### **AMENDMENTS TO THE DRAWINGS**

Fig. 3

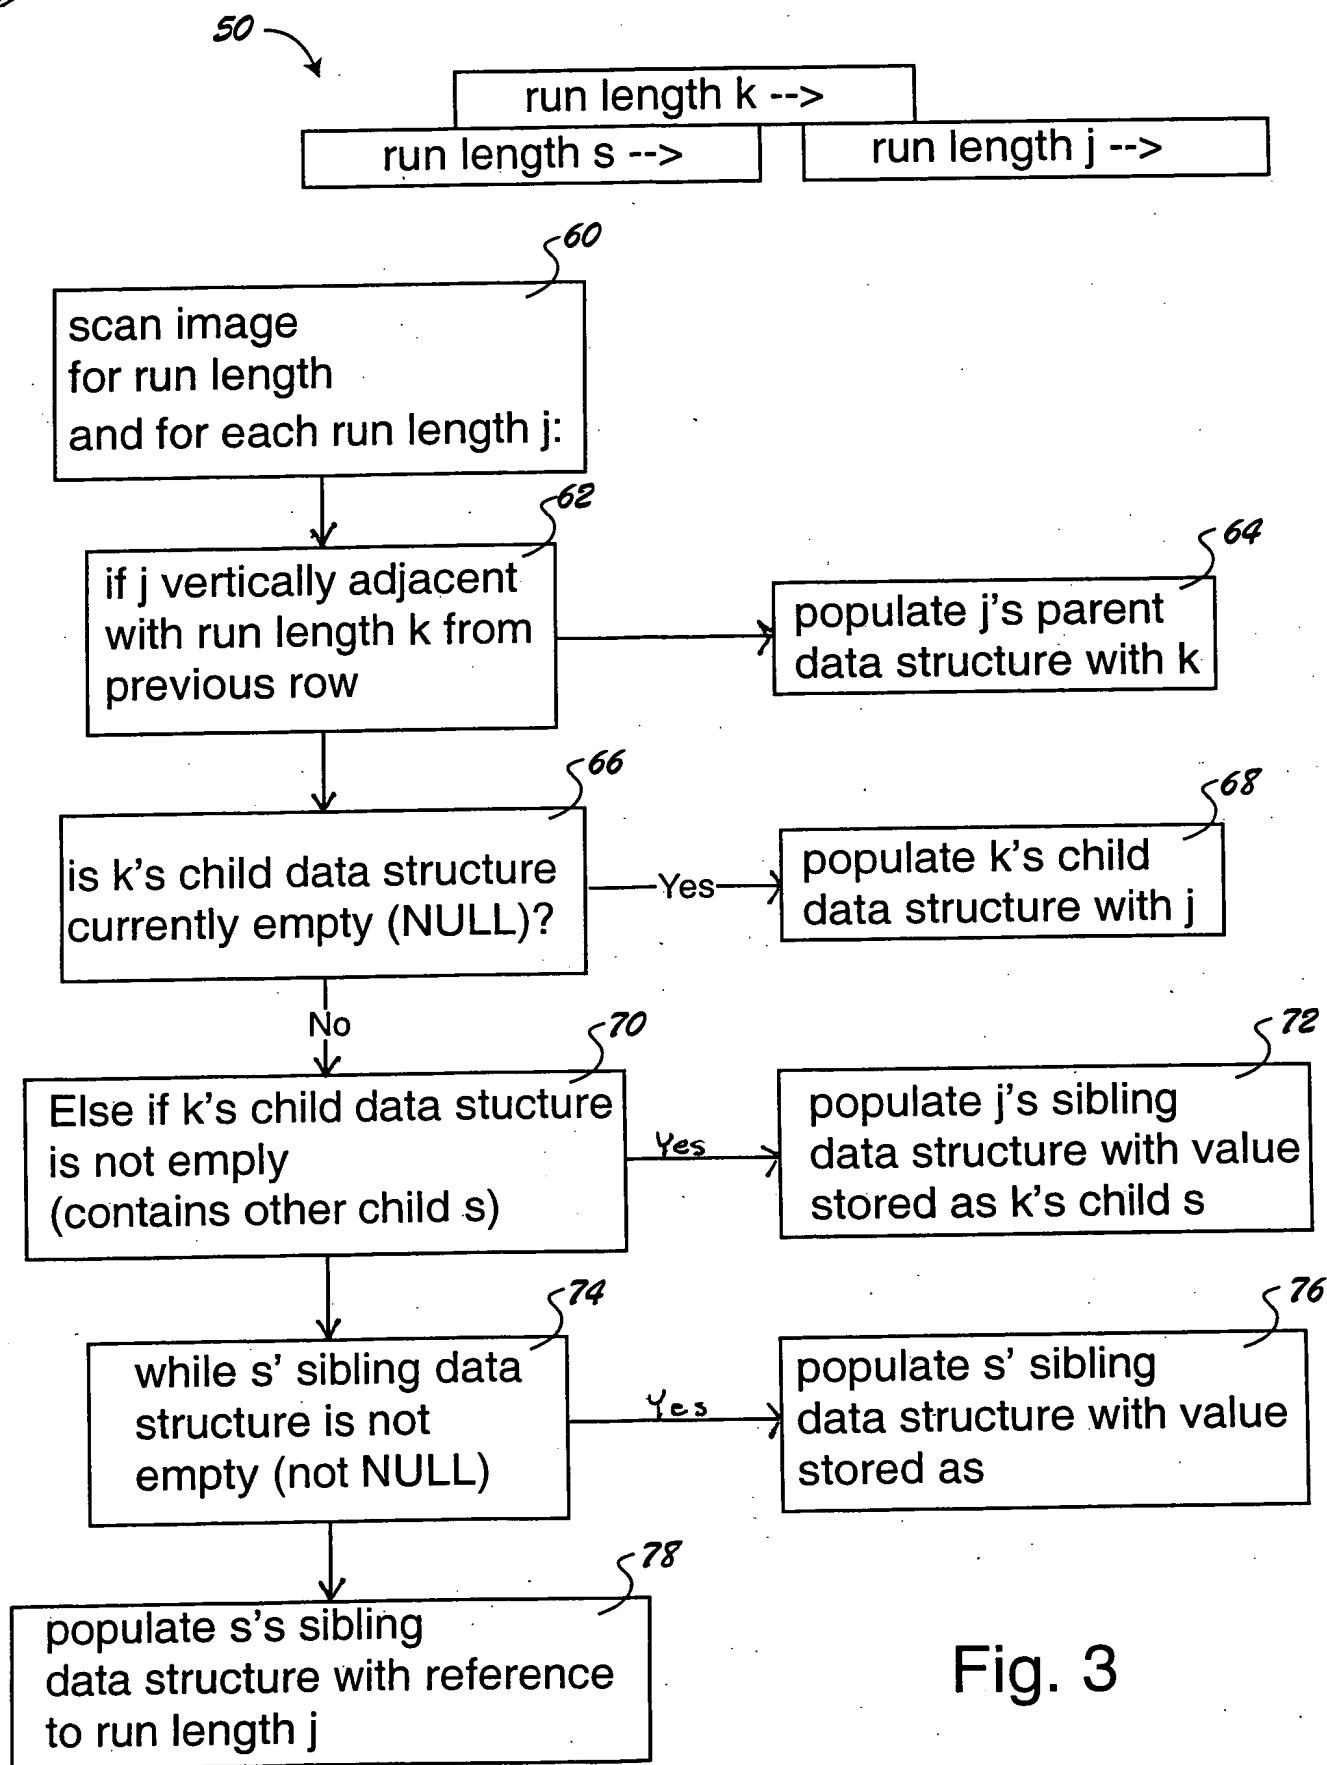
The attached "Replacement Sheet" for Figure 3 clarifies the flow from blocks 70 to 74. Approval of these changes is respectfully requested.
